Thor Motor Coach Technical Service Bulletin

TSB #	TSB 26-04		
Description/Title:	Radio fuse		
Affected Product Line(s):	Certain model year 2025 Eddie Bauer 2025-27 Axis 2025-27 Vegas		
Service Campaign # :	RC000341		
Codes:	Inspect with Repair: TMCTS10130J	Document Date:	7/6/2026
Time Allowed:	Inspect with Repair: 0.2	Document Revision:	A

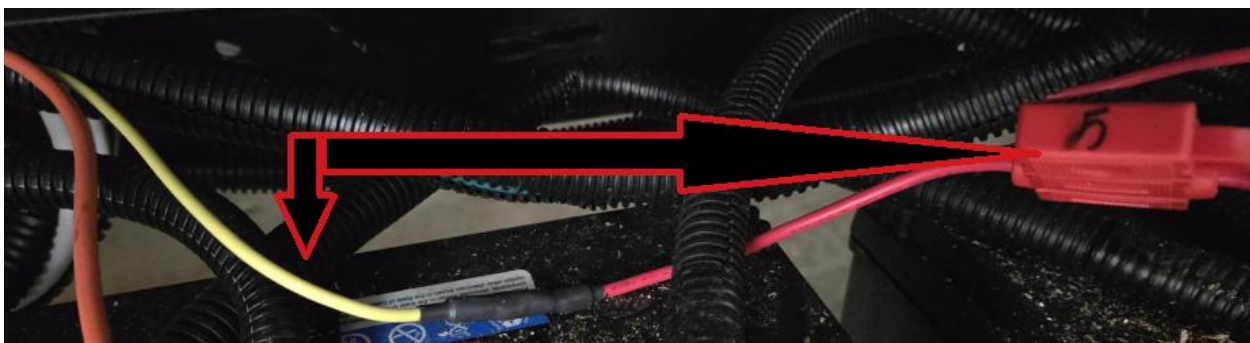
It has been discovered the dash radio in-line fuse was installed with the incorrect fuse size. Production installed a 5A fuse when it should be a 15A fuse. The undersized fuse greatly reduces the surge allowance during normal operation. The wire for the dash radio is 14 gauge and is compatible with a 15A fuse.

1. Gain access to the house batteries located under the inside stepwell of the entry door.

2. Locate the in-line fuses connected to the positive (+) side of the battery.

3. The fuse holder labeled '5' will need the 5A fuse changed to a 15A fuse. Verify the wire inside the loom is yellow, which represents the dash radio.

4. Once the fuse has been changed to 15A, add a '1' before the '5'.
